**ADERRIG PHASE 2,  
ADAMSTOWN,**

**RESPONSE TO  
CLARIFICATION OF FURTHER  
INFORMATION- SDZ21A/0014**

**ARCHITECTURAL  
COMMENTS**

**JANUARY 2022**

Typical parking vs tree arrangement on Linear Park Road (Site layout Drawing extract)

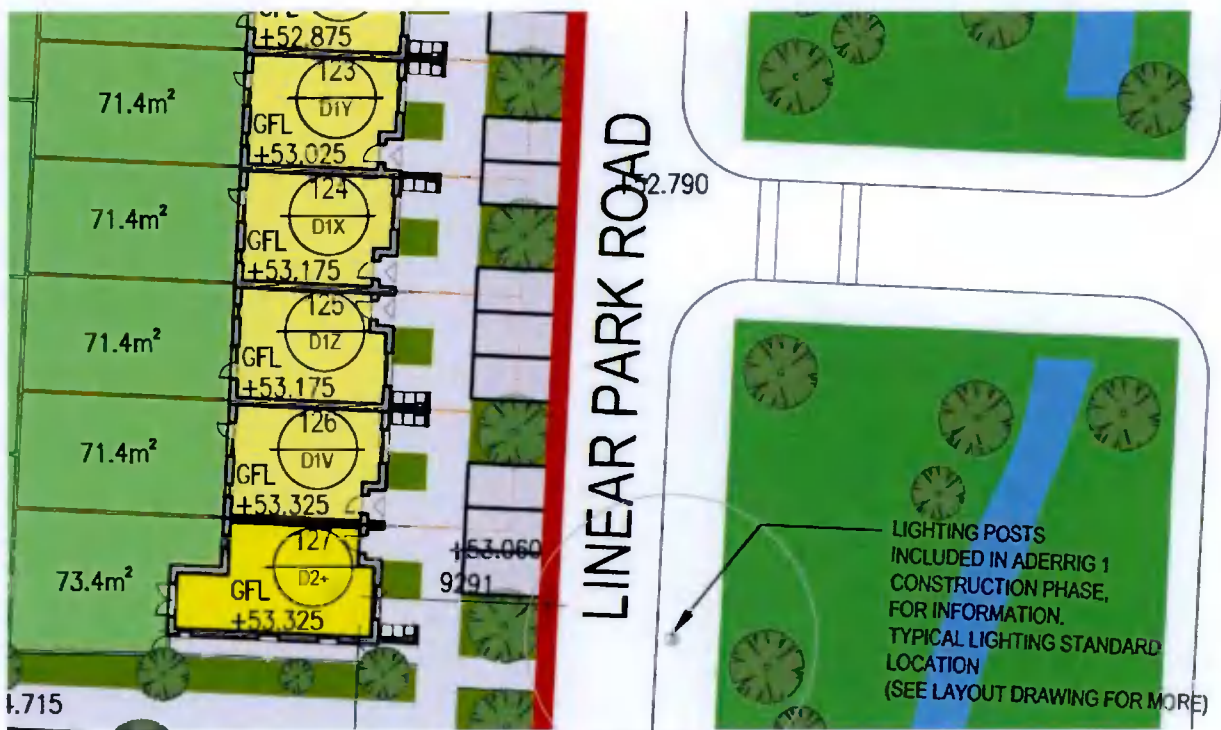
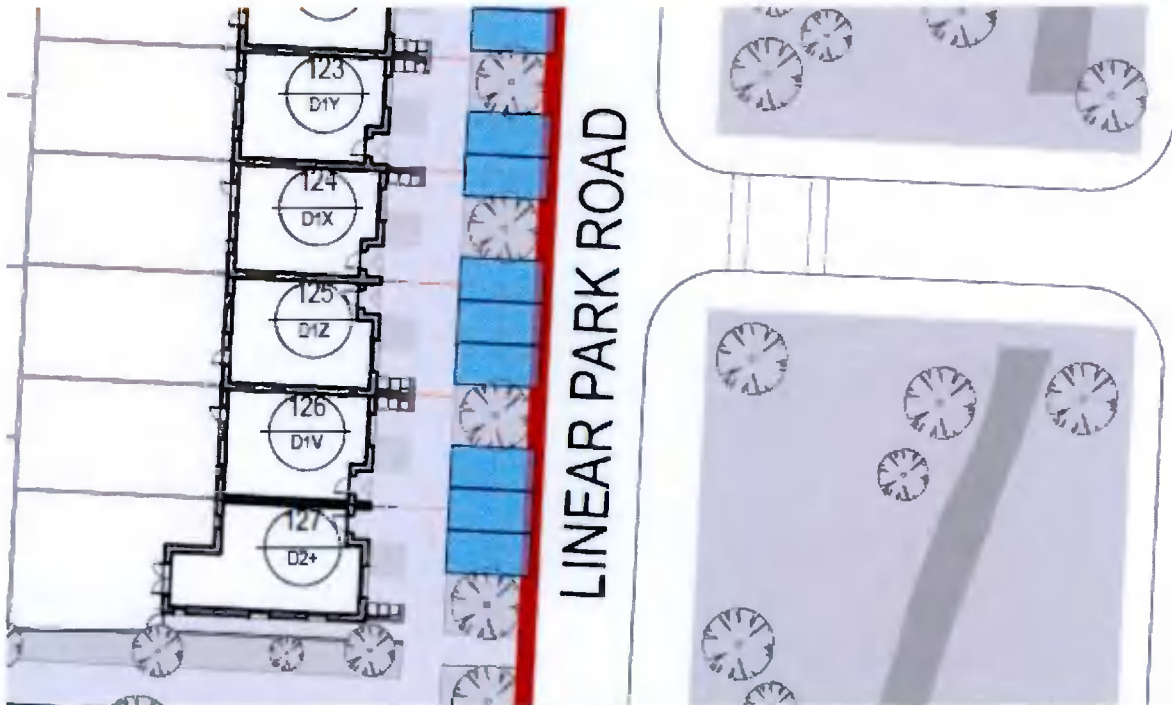
**(1) The provision of Street trees along Linear Park Road (Avenue), integral to the street, has not been achieved and the response to the AI request is not satisfactory. In order to achieve street trees that are integral to the street, the applicant is requested to provide the following:**

**(a) Additional space for tree planting integral to the street;**

**(b) Move the footpath to the rear of the car parking so street trees can be integral to the street;**

**(c) Provide parallel parking along Linear Park Road (Avenue) with integrated street trees every two or three car parking spaces.**

The parking and tree planting arrangements along the Linear Park Road (Avenue) on the eastern site boundary have been reconfigured so that all parking on this road is now located adjacent to the road with the footpath located between the parking bays and the dwellings. The parking bays have been reconfigured to provide 2 to 3 parking spaces (with a maximum of 3 parking spaces) between landscaped islands for the provision of street trees along the length of the road. Each tree planting zone will be between 3.5m and 4.4m wide depending on location. The parking bays are configured in a perpendicular rather than parallel format in order to provide adequate parking to the 4 bed dwellings along Linear Park Road. Section 1.5.2 of the AD SG facilitates a flexible approach and allows SDCC to grant permission for design solutions other than those presented, as long as the approach accords with the objectives of the document 'particularly where they represent up-to-date design philosophies and/or are more environmentally sustainable solutions', it was deemed acceptable to the Council at the meeting on the 14/1/2022. Please refer to Atkins note which outlines the rationale for perpendicular parking along this Avenue and adherence with DMURS.

We respectfully contend that the combination of the reduced dominance of parking along the Linear Park Road and the introduction of street trees at approximately 11m centres adjacent to the carriageway will successfully address the issues raised and will create an appropriate Avenue environment in accordance with the general intention of the SDZ and the Adamstown Street Design Guide.

Adamstown Way – Parking now proposed (5 parking space – red dots) ( accessible spaces hatched green)

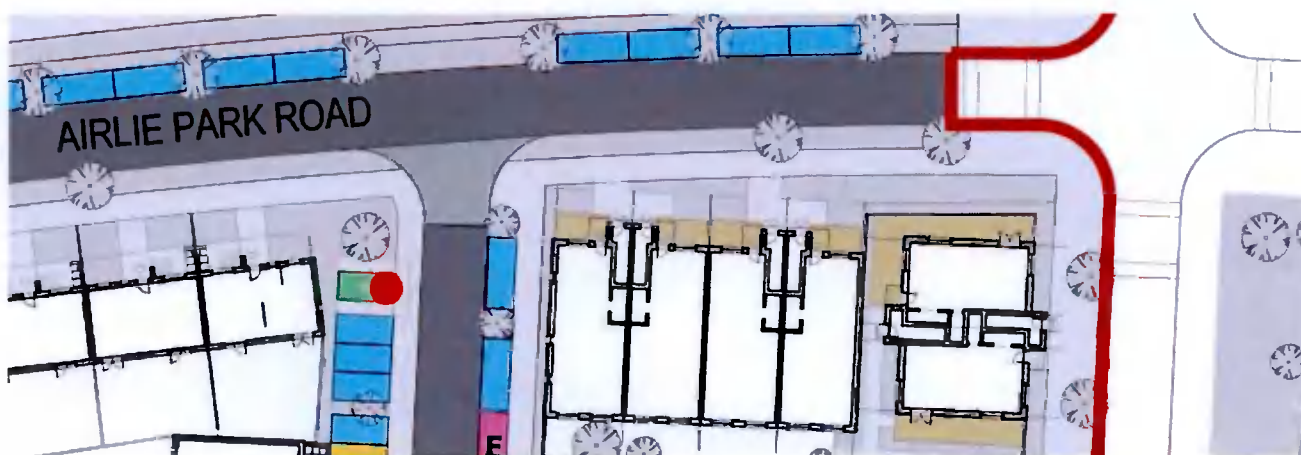
In the RFI dated 28 July 2021 the Council had queried the absence of parking along the western end of Adamstown Way. It was previously believed by the clients Design Team that the level of the existing live services along the line of the potential parking zone precluded the delivery of spaces in this area. However, late in Q4 of 2021 site investigations established that the services are in fact located at a depth which would not hinder the delivery of parking in this area provided that the visibility splays for vehicles at the adjoining junctions are not affected. The provision of a limited number of parking spaces along Adamstown Way also supports the ground floor duplex units in this area which are all accessed from Adamstown Way and must otherwise park at Home Zone 3 or Side Street 4. On this basis two of the parking spaces at the eastern end of Adamstown Way have been combined to provide an accessible parking space and four spaces (including an accessible parking space) are proposed at the western end. The spaces are highlighted on the diagrams below for clarity.

Orange hatch shows areas in OMC control, blue hatch SDCC taken in charge (Taking In Charge Drawing extract)

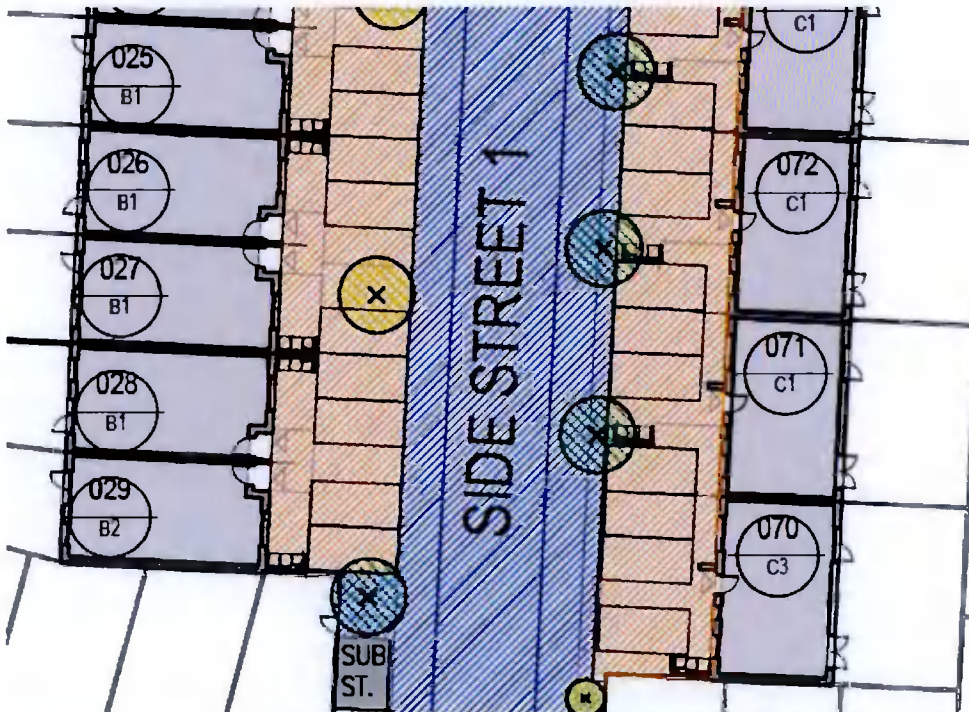
(2) The submitted parking strategy, which indicates 'off-curtilage' spaces within the curtilage of dwellings on side streets 1 and 4, is considered to be inappropriate and it is unclear how this can actually operate on the ground. The applicant is requested to provide a revised parking strategy which addresses this matter, the parking should either be all off-curtilage or all on-curtilage (unless it can be clearly demonstrated how both on and off can operate alongside each other).

All of the parking spaces on the eastern side of Side Streets 1 and 4 are now shown off curtilage and under the control of the Owners Management Company to address the Councils concerns.
